Wisconsin Department of Transportation

Proposal #50: 8337-00-70, WISC 202211
T Barnes, South Shore Road
Eau Claire Lakes Br B-04-0124
Local Str
Bayfield County

This is Addendum No. 01, which provides for the following:

Addendum No. 01
ID 8337-00-70
Revised Sheet 39
February 1, 2022

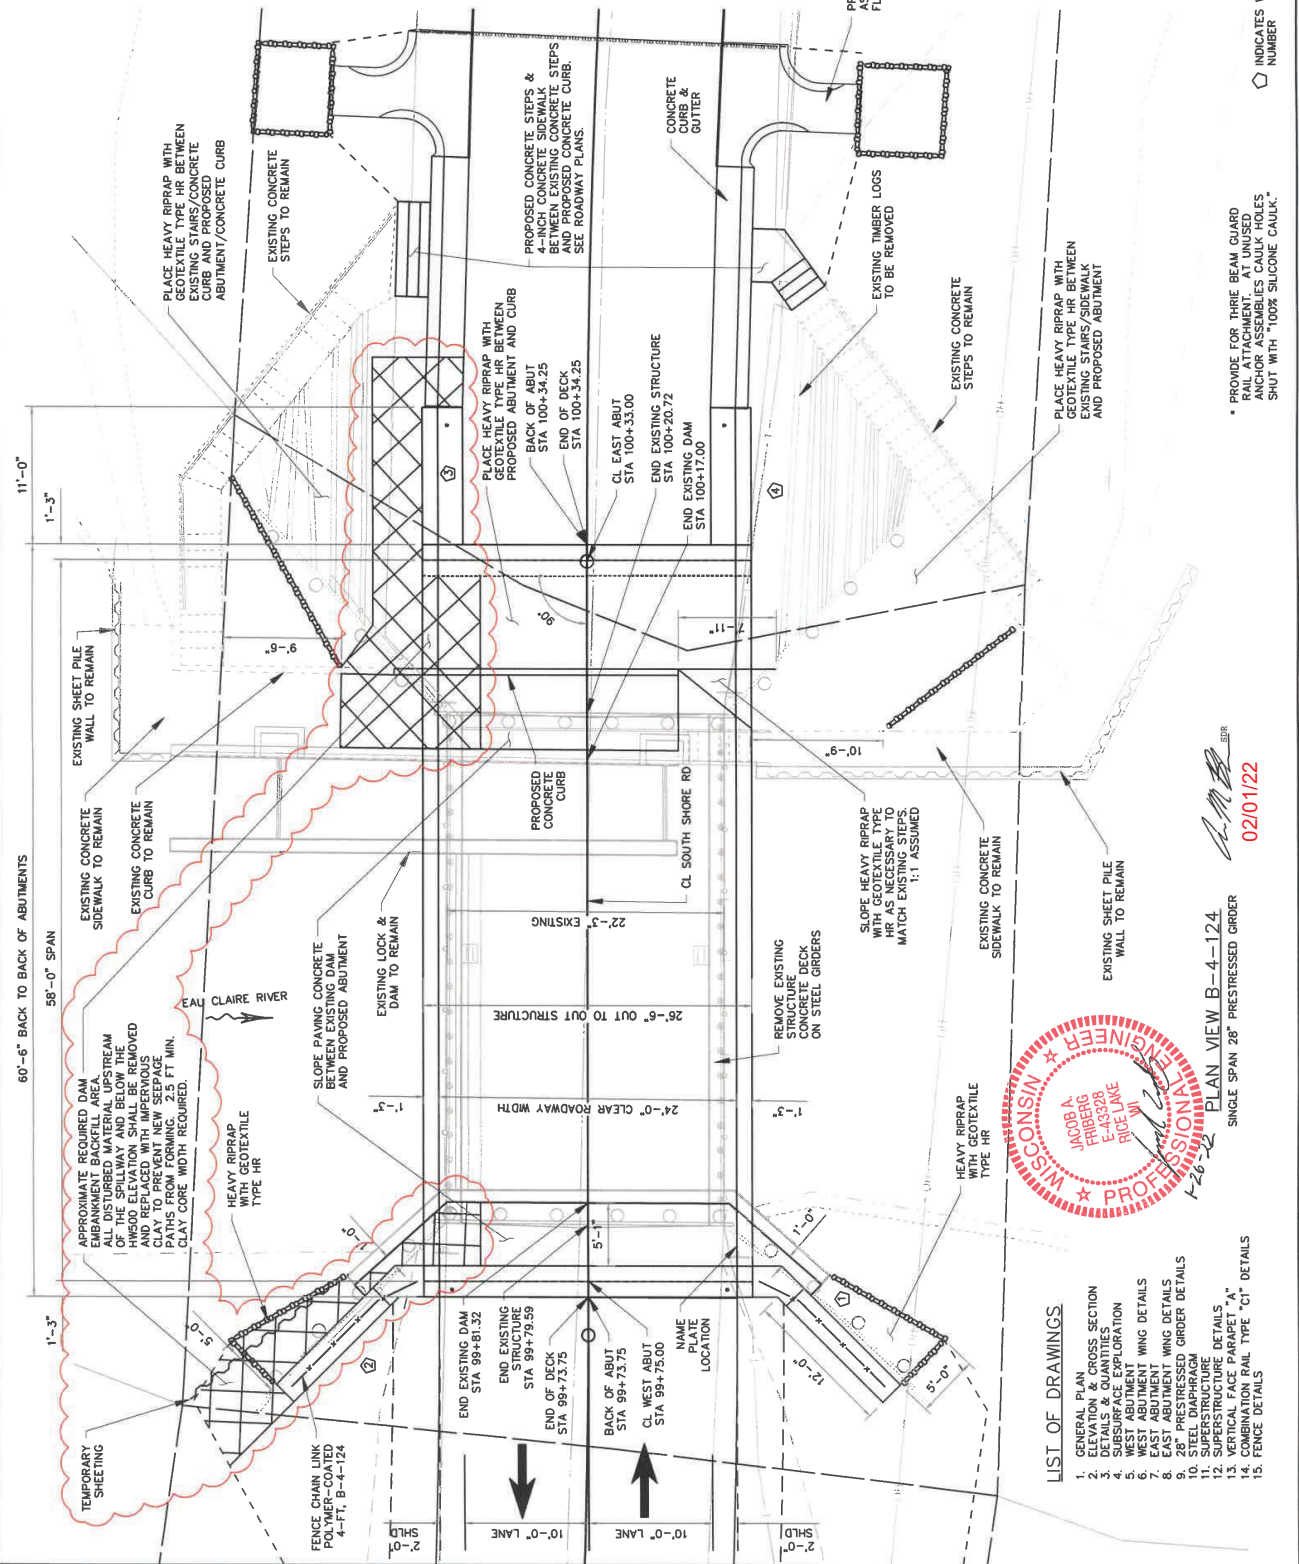
Revised Plan Sheets	
Plan Sheet	Plan Sheet Title (brief description of changes to sheet)
39	Structure B-4-124 General Plan (added approximate required dam embankment backfill areas to the plan view)
40	Structure B-4-124 Elevation & Cross Sections (added approximate required dam embankment backfill areas to the elevation view)
41	Structure B-4-124 Details & Quantities (Added new detail section view at wing showing dam embankment backfill. Added 2 new bid items to Total Estimated Quantities table)

NO.	DATE	REVISION	BY
1	1/26/22	DAM EMBANKMENT BACKFILL	JF

Addendum No. 01
ID 8337-00-70
Revised Sheet 40
February 1, 2022

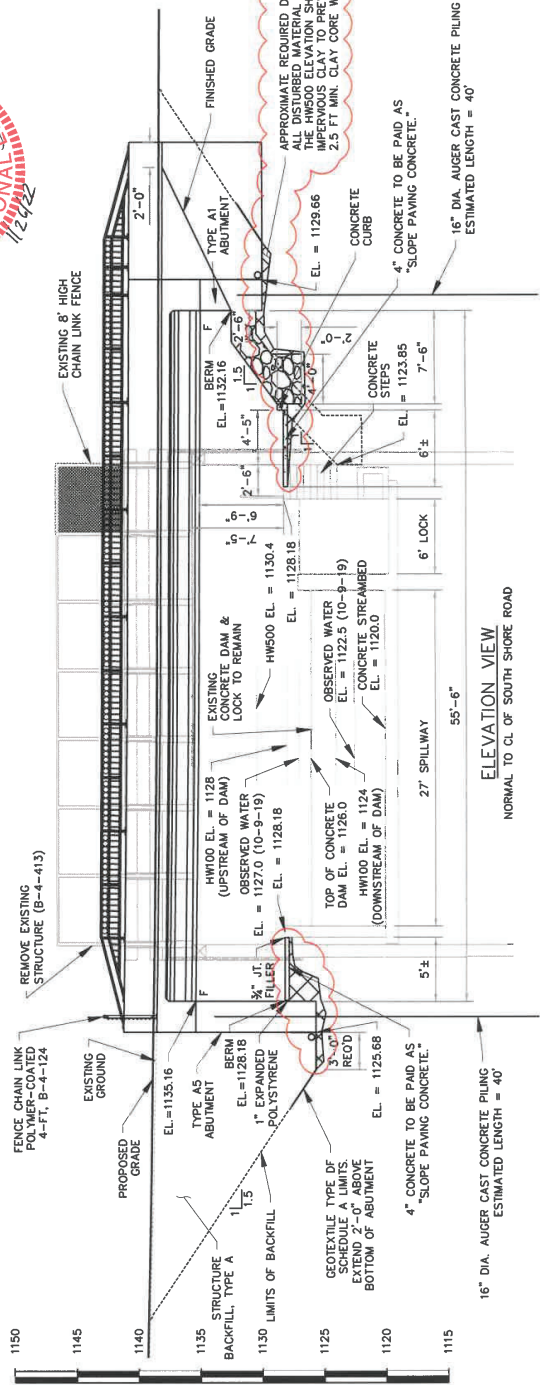
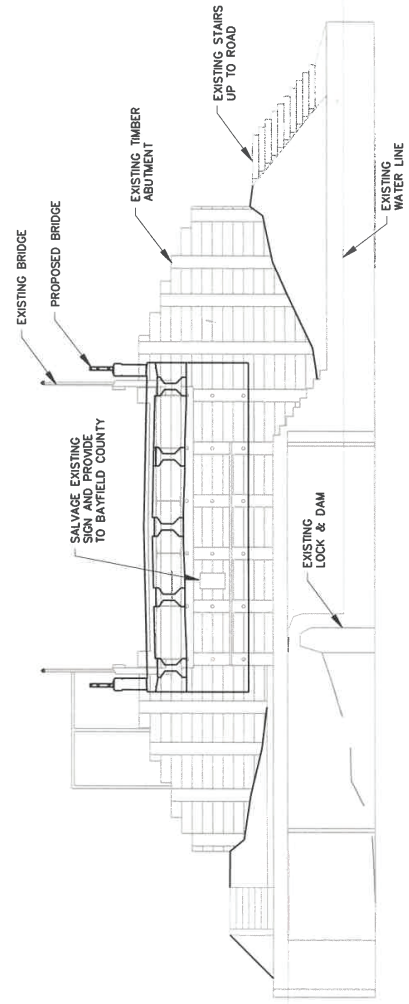
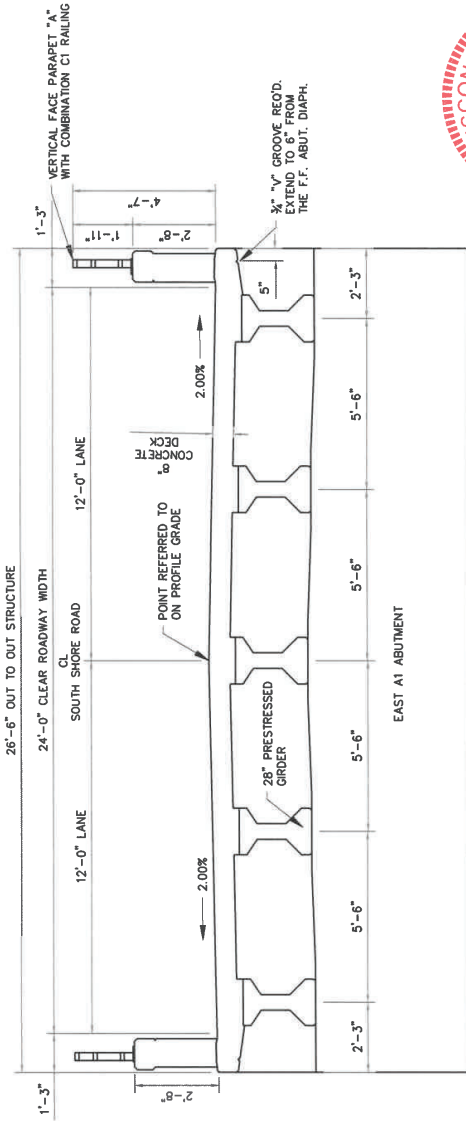
NO.	DATE	REVISION	BY
1	1/28/22	DAM EMBANKMENT BACKFILL	JF

Addendum No. 01
ID 8337-00-70
Revised Sheet 41
February 1, 2022

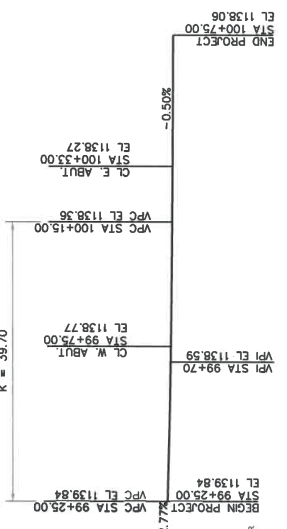
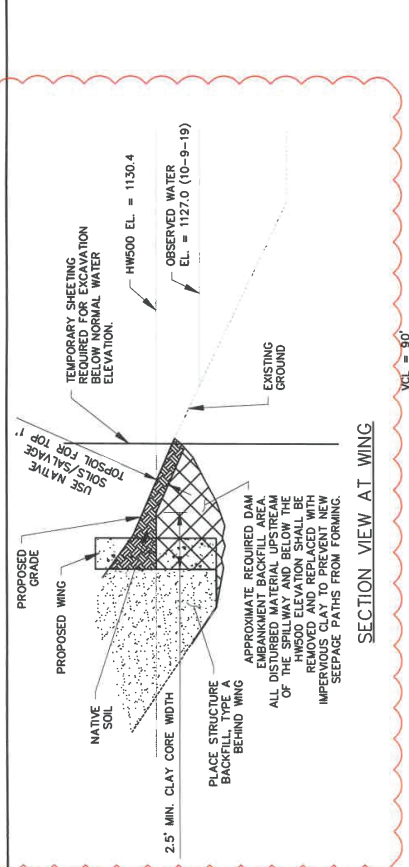
NO.	DATE	REVISION	BY
1	1/28/22	DAM EMBANKMENT BACKFILL	JF
